ANDOVER TOWN YARD WRITTEN QUESTIONS

EXHIBIT A

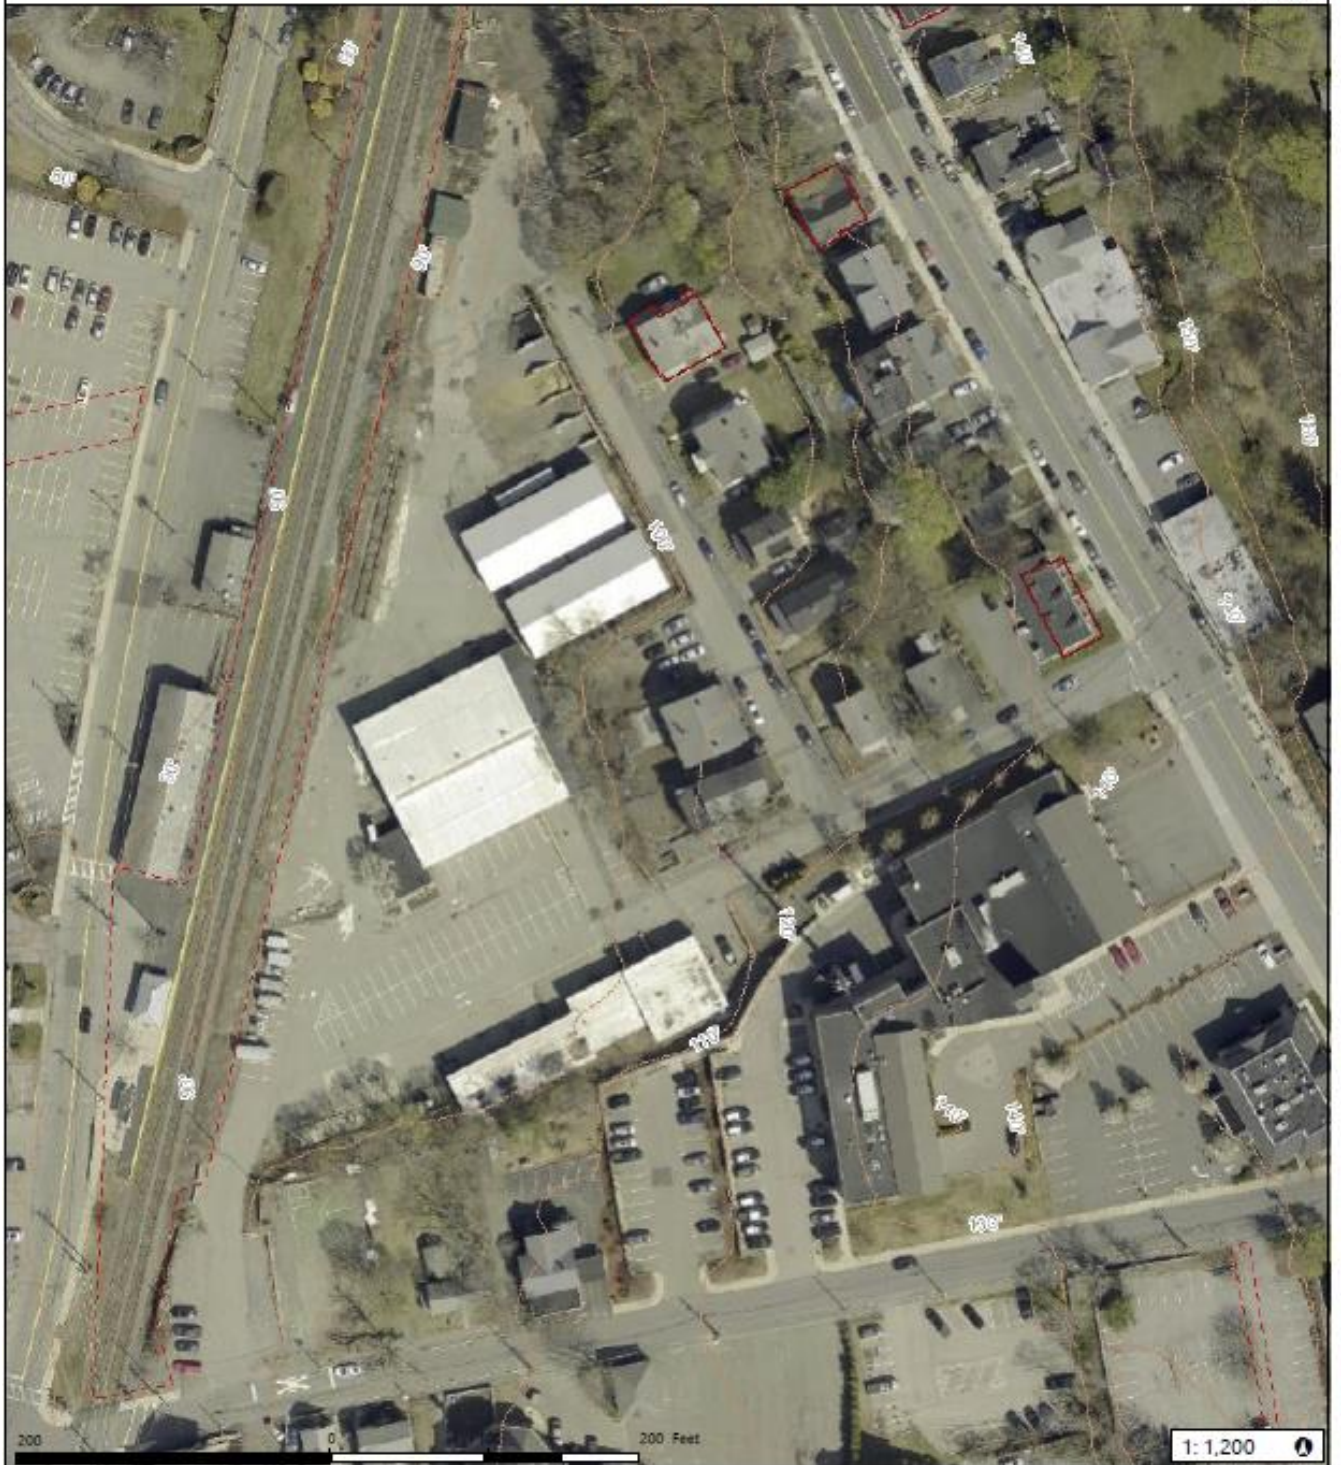
10. Is there a topography plan?
 - A topography plan is attached here as Exhibit A. Per page 5 of the RFP, there is an approximate 18-foot grade change from the lowest to highest point, but these are estimated figures and Proposers will be expected to confirm topography changes as part of their own due diligence.
